**RAYMONDVILLE DRAIN PROJECT
ENGINEERING APPENDIX A1**

FINAL TECHNICAL MEMORANDUM SUMMARY OF QUALITY ASSURANCE REVIEW HYDROLOGY & HYDRAULIC BASE MODELS

Raymondville Drain Project, Project for Flood Control

SUMMARY OF QUALITY ASSURANCE REVIEW FOR THE HYDROLOGIC / HYDRAULIC (H&H) BASE MODELS

NHD BASE MODEL - CSF - Plan NMDI-HASH MODEL AMC SAR 2011 L0WS
Copy of 224370

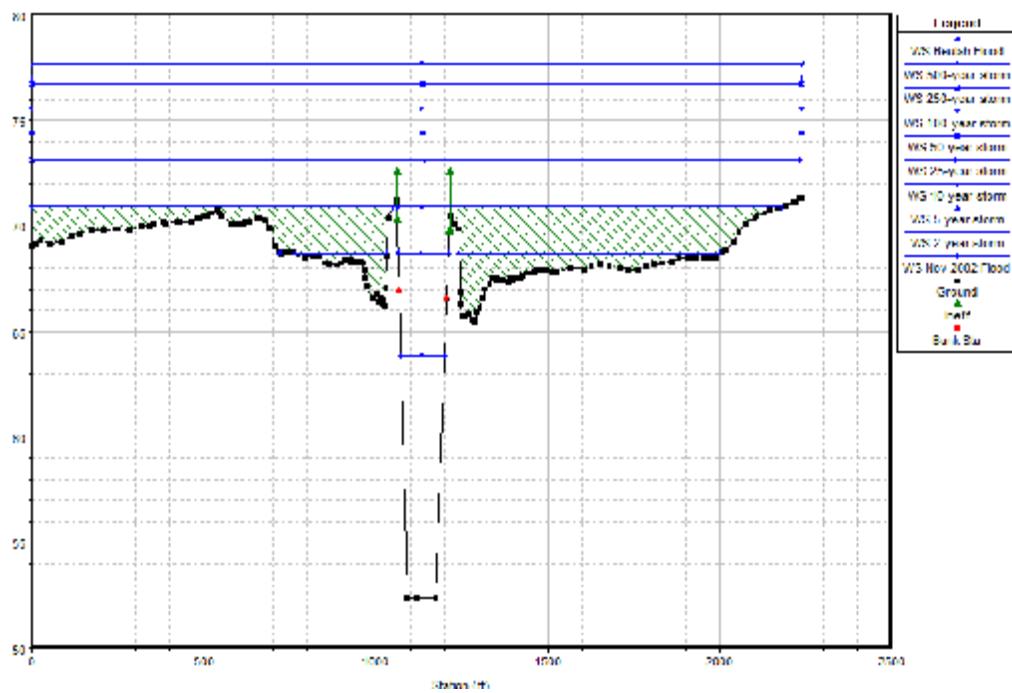
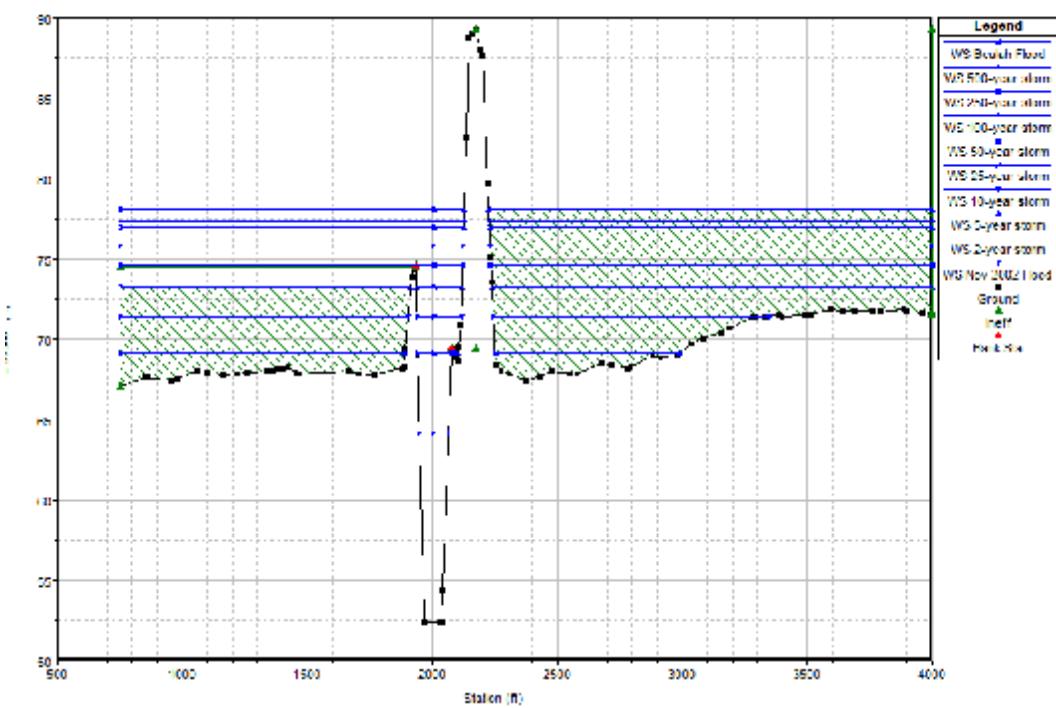
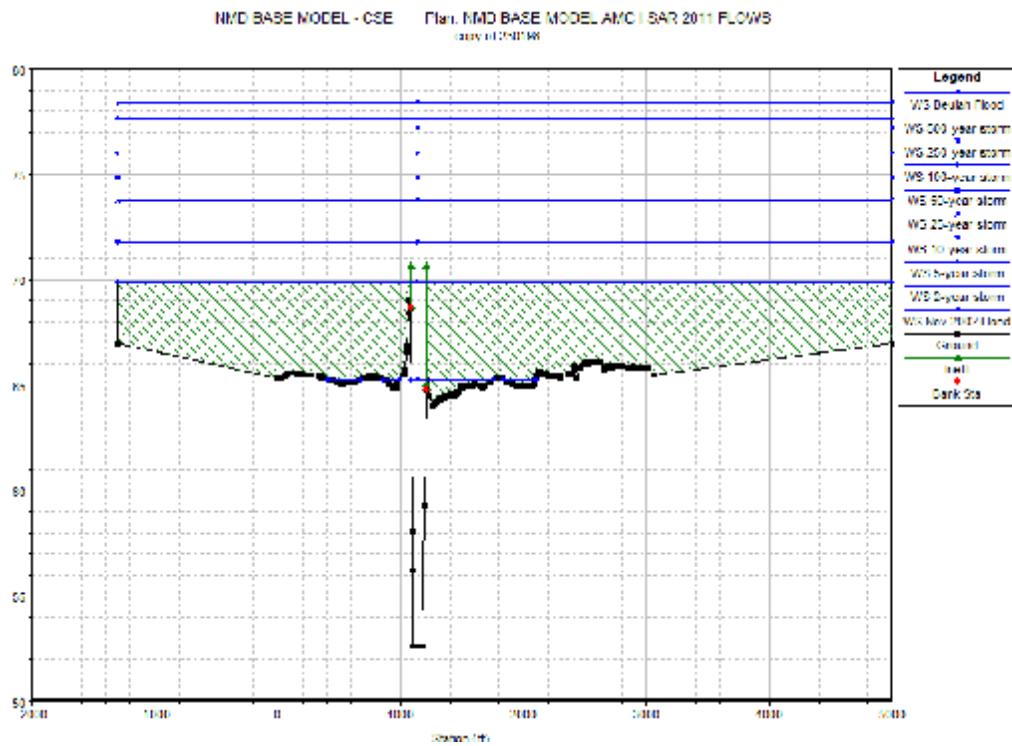
4. Some of the storage-outflow relations from HEC-RAS modeling need to be revisited. It was noticed in the HEC-RAS model, storage is overestimated (see following cross sections with water surface elevations).

S&B Response: Storage-outflow tables were taken directly from HEC-RAS. Many of these reaches contain data that was obtained directly from the models provided to S&B by the USACE. There was significant coordination with the USACE during 2007 to ensure that storage values utilized by S&B corresponded with the values in the USACE models. Due to the extremely flat terrain found in these areas, there will be significant storage in the overbanks once the water surface has risen above the banks of the channel.
